**DOCUMENT 00 90 00  
ADDENDUM**

**ADDENDUM NO. [2]                      Date: January 5, 2022**

**RE:                      SCHOOL DISTRICT OF ABBOTSFORD  
ABBOTSFORD SCHOOL DISTRICT FEMA ADDITION  
510 WEST HEMLOCK STREET  
ABBOTSFORD, WISCONSIN 54405  
HSR PROJECT NO. 21027**

**1** **ENLARGED UPPER LEVEL PLAN**  
1/4" = 1'-0"

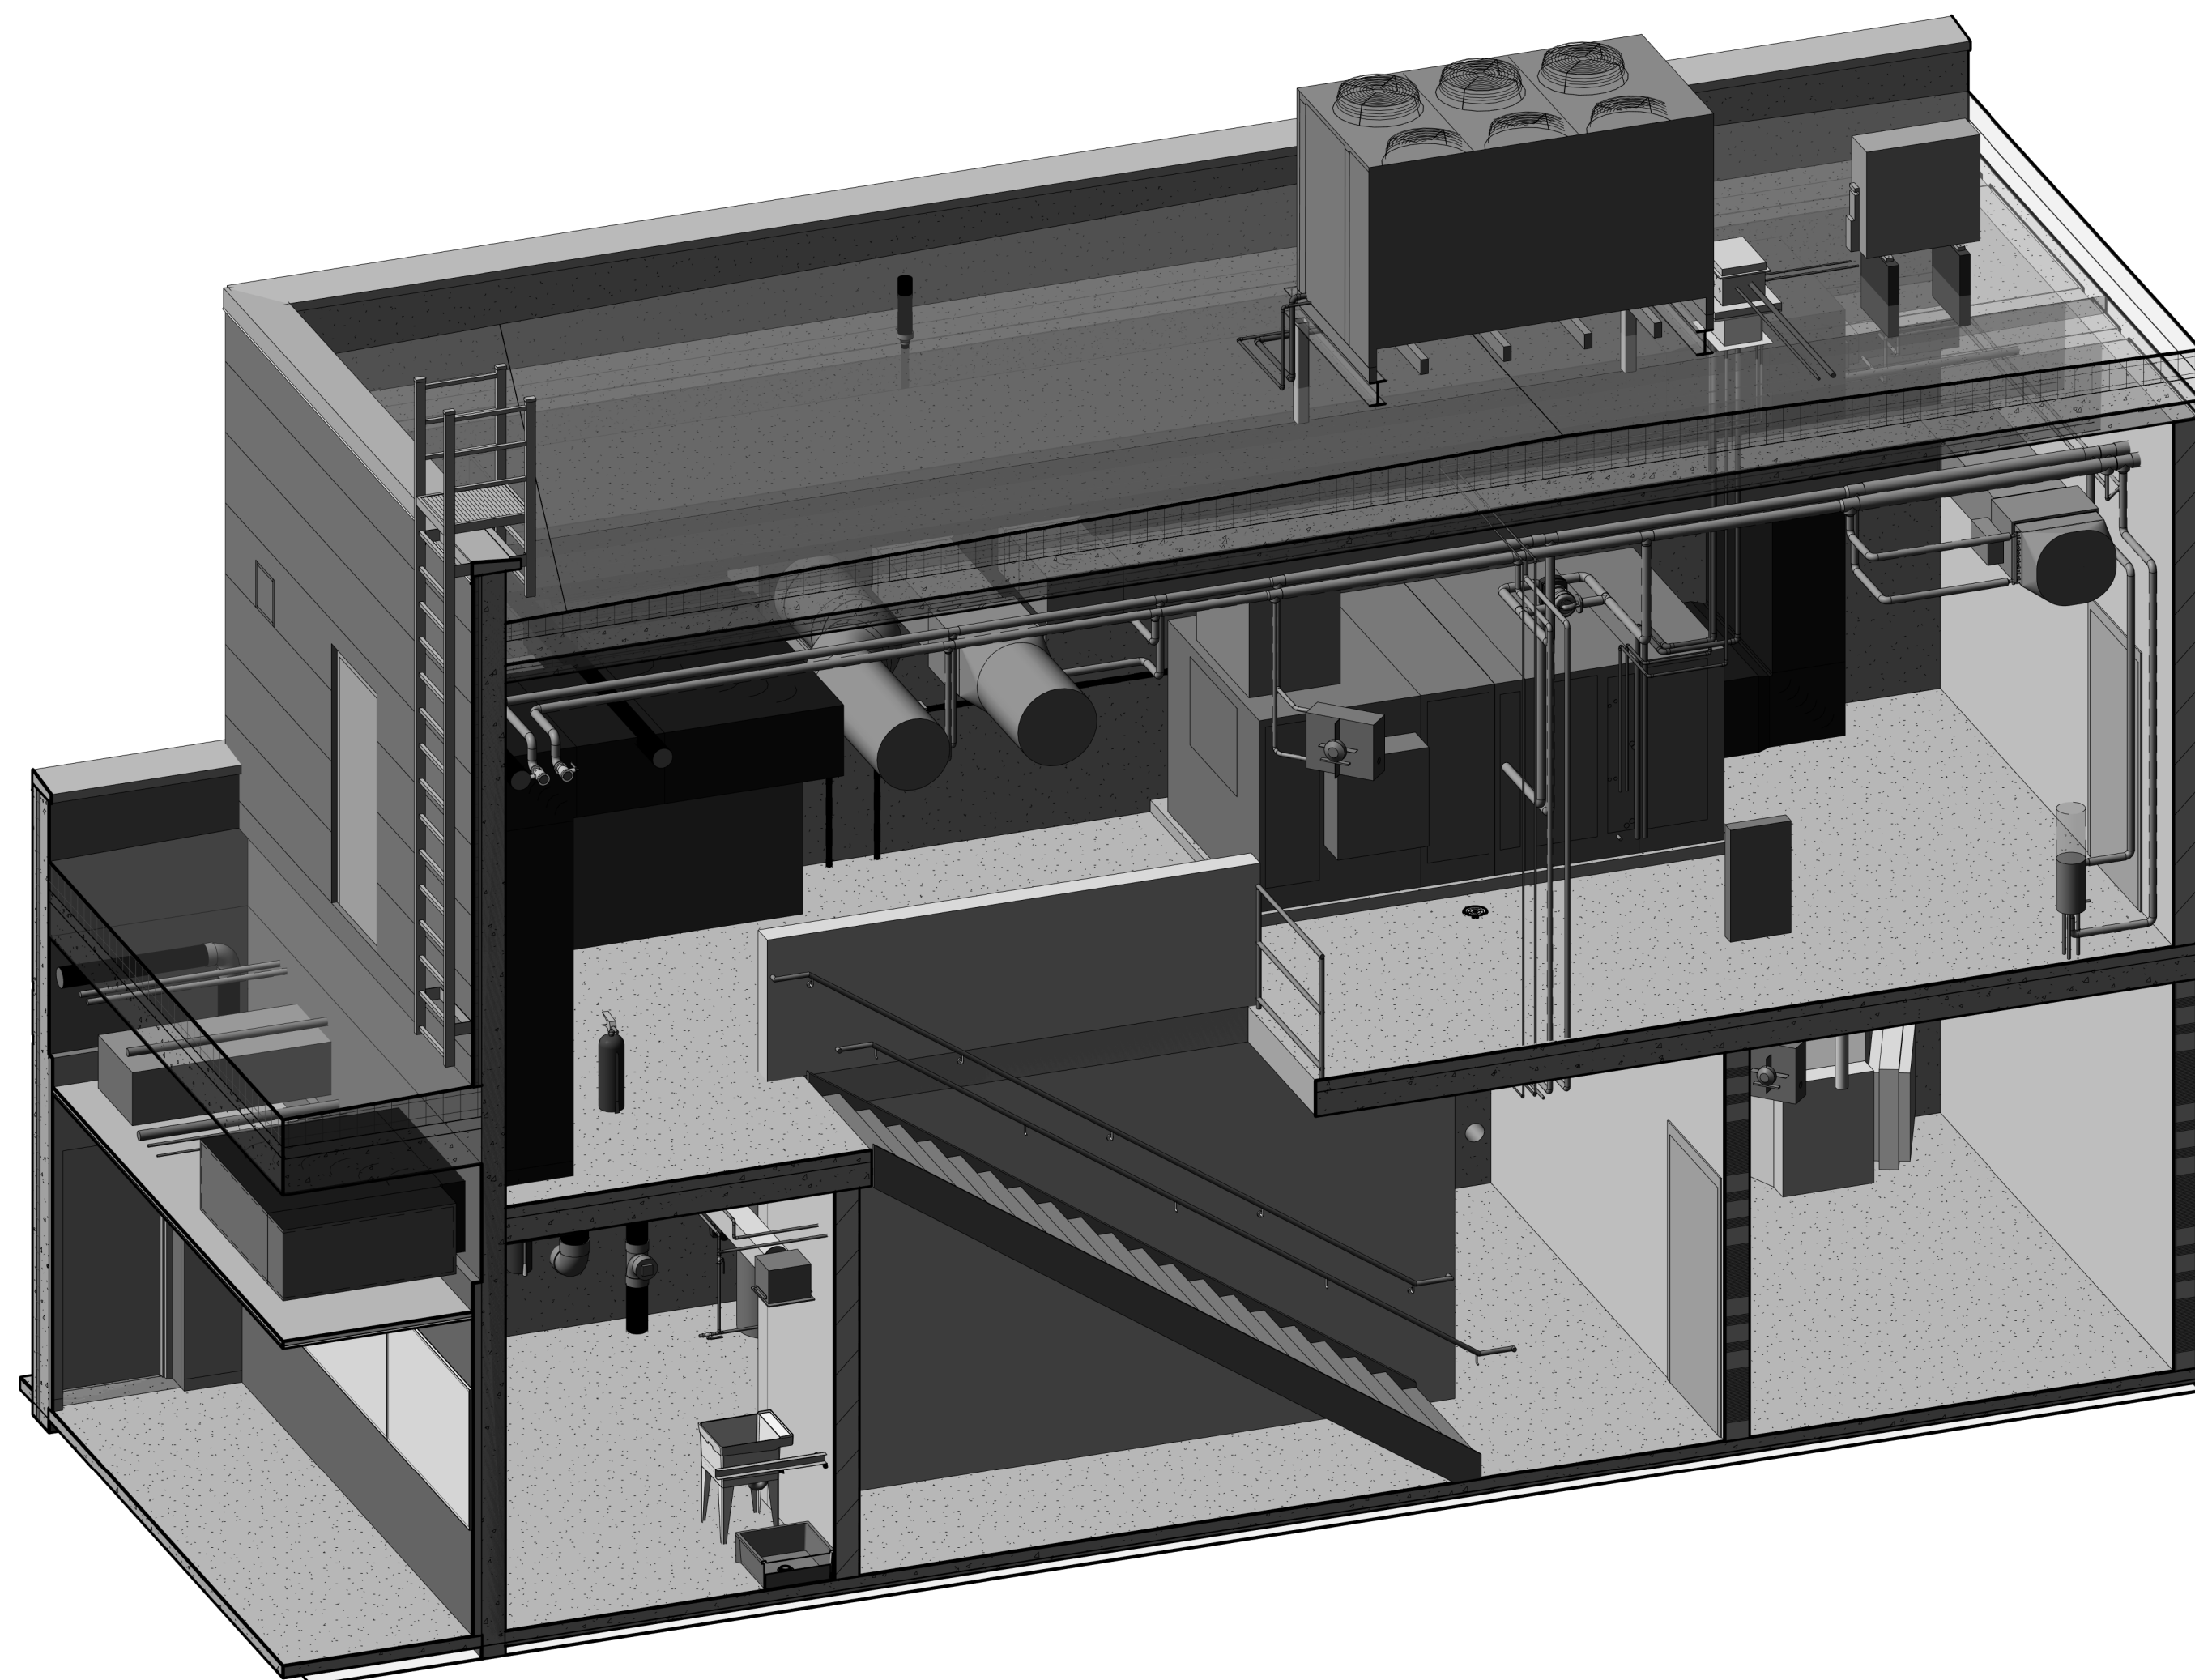
22. Sheet M200 ENLARGED UPPER LEVEL PLAN revised 30 x 42 sheet attached hereto.

- a. Added louver L-9, with gravity backdraft damper and 8"x8" duct from EF-2 below.
- b. Revised size of L-1.
